CASE SUMMARY
Design Adjustment Committee

Design Adjustment
November 20, 2024

DAC-6-1124

<i>Address</i>	901 S. Front Street	
<i>Acreage</i>	Approximately 2.6 acres	
<i>Request</i>	Request for design adjustments for driveway offsets and driveway design standards for a residential development.	
<i>Consultants/ Agents</i>	Jimmy Fentress Stroud Engineering, PA 102-D Cinema Drive Wilmington, NC 28403	(910) 815-0775 jffentress@stroudengineer.com
<i>Property Owner</i>	John Donoghue Le Dome Holdings LLC 901 S. Front Street Wilmington, NC 28401	(910) 409-5533 john@capefearsolarsystems.com
<i>Pre-TRC Review</i>	August 22, 2024	
<i>Design Adjustment Committee Action</i>	11/20/24; Scheduled for evidentiary hearing

Figure 1. Proposed Site Plan (Attachment 4)

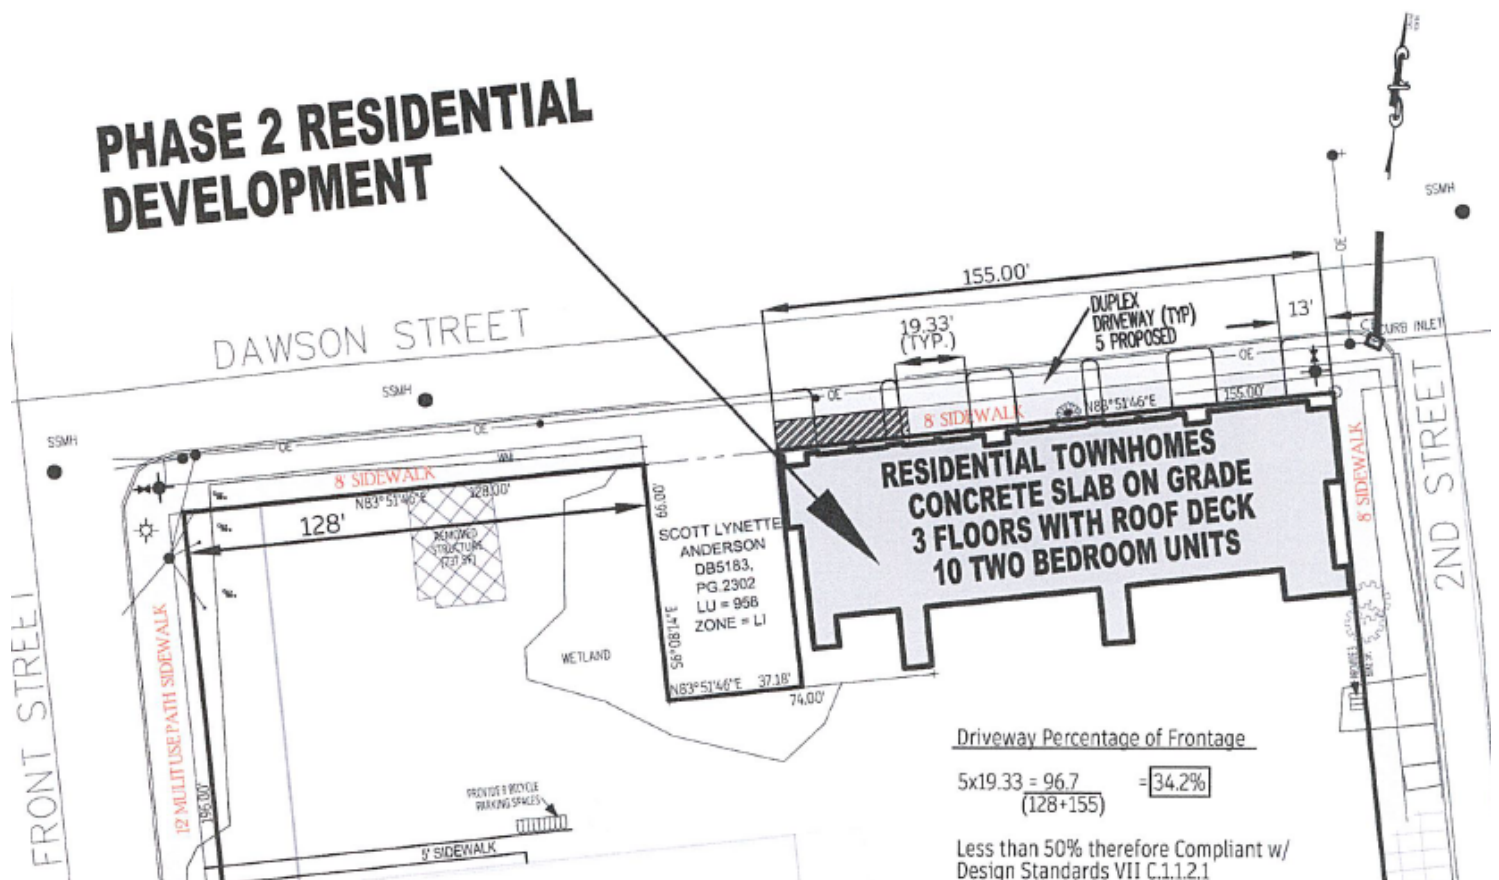
3. The applicant proposes to construct a 10-unit residential development on the northeast corner of the site.
4. Five new residential driveways are proposed along this portion of Dawson Street.

6. The *Technical Standards and Specifications Manual* stipulates that no driveway curb return or edge of driveway apron at its intersection with the roadway shall be allowed within twenty-six (26) feet of the point of intersection of the street property lines at an intersection or street corner. The applicant proposes a 13 foot offset and a waiver is required.

7. The *Technical Standards & Specifications Manual* (TSSM) specifies a minimum residential driveway taper of 5 feet. The applicant proposes no taper and a waiver is required.

Adjustment	Requirement	Proposed
<p>1 Driveways – Private Driveway Offset: No driveway curb return or edge of driveway apron at its intersection with the roadway shall be allowed within twenty-six (26) feet of the point of intersection of the street property lines at an intersection or street corner. CH. VII (C)(1)(c)(10)</p> <p>Applicant’s Justification: The first driveway is proposed thirteen feet from the right of way intersection. Dawson Street is only one block in length at this location. The Memorial Bridge off ramp occupies what would have been Dawson's continuation with that to the east as shown on the 1945 limits map. This results in the portion of Dawson Street adjacent to his project to being a local road serving primarily only the adjacent block. There is very little traffic on this segment of road, which was built as a collector, three lanes wide. The driveway traffic will be mitigated by the finished pavement's excess width. The street side parking that has historically served this block will be prohibited along the immediate frontage allowing for additional room on the road. Were the driveway sited so as to provide twenty-six feet to the intersection there may be a tendency for visitors to use as a parking space. The thirteen feet provided should be too constraining for such consideration.</p>	26 feet	13 feet

Adjustment	Requirement	Proposed
<p>2 Residential Driveway Taper Standards – Vertical Curb (SD 3-03.1)</p> <p>Applicant’s Justification: There was no mention of any required deviation from this standard however when revising the plan to address the review comments it becomes apparent that the standard residential driveway will not work as the required five feet tapers overlap. On this basis, we are requesting the Committee consider allowing the use of a prior standard that does not have tapers. This is the type of driveways that were used for other residences in the neighborhood.</p>	5 feet	None
